# UNITED STATES PATENT AND TRADEMARK OFFICE

10/777,097

**Office Action Summary**

FIG. 13

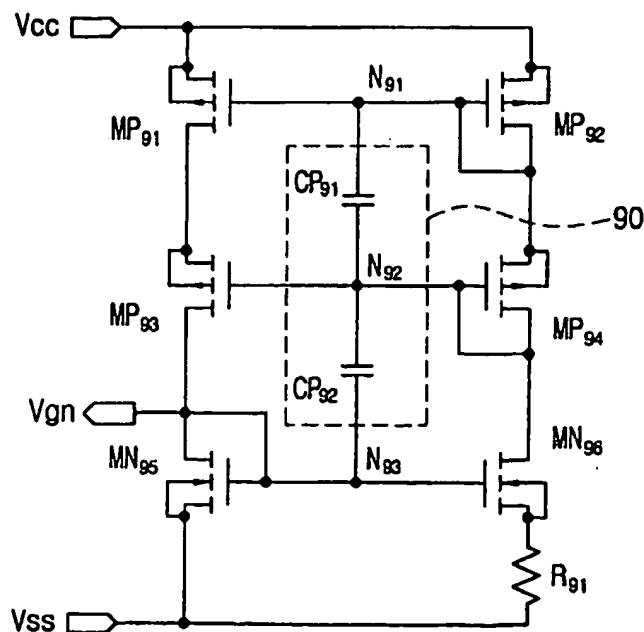
6. All 112 rejections are withdrawn in light of Applicant's amendments. The drawing amendments are also acceptable. Of course the output nodes were implied in Fig. 13 and 14. Just as they are implied in Examiner's relied upon references. Examiner is

Okay  
to  
enter  
JZ  
8/14/06

FIG. 14

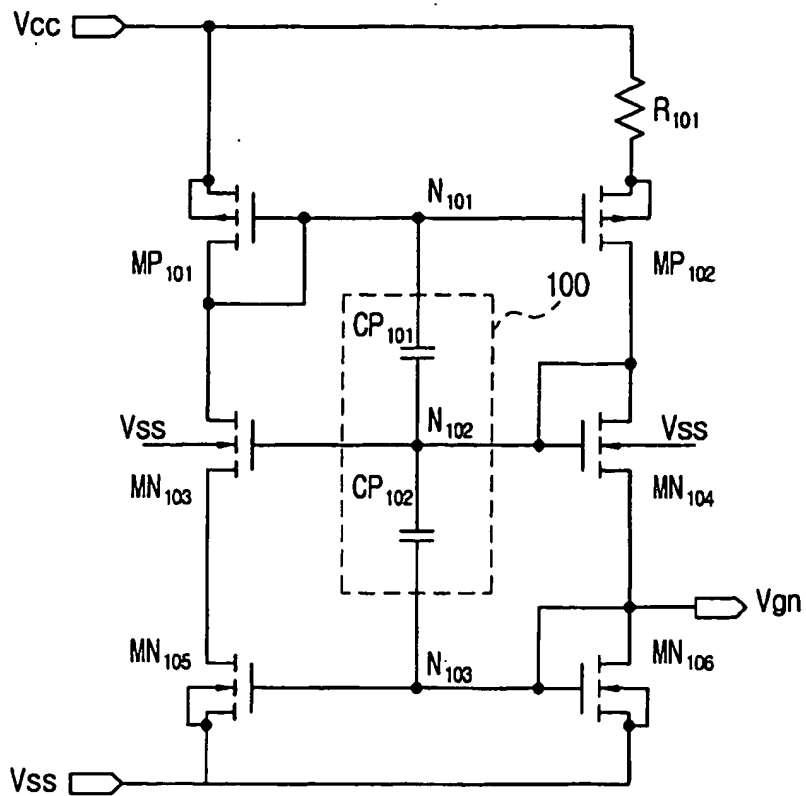
Okay  
to  
enter  
JZ  
8/14/06
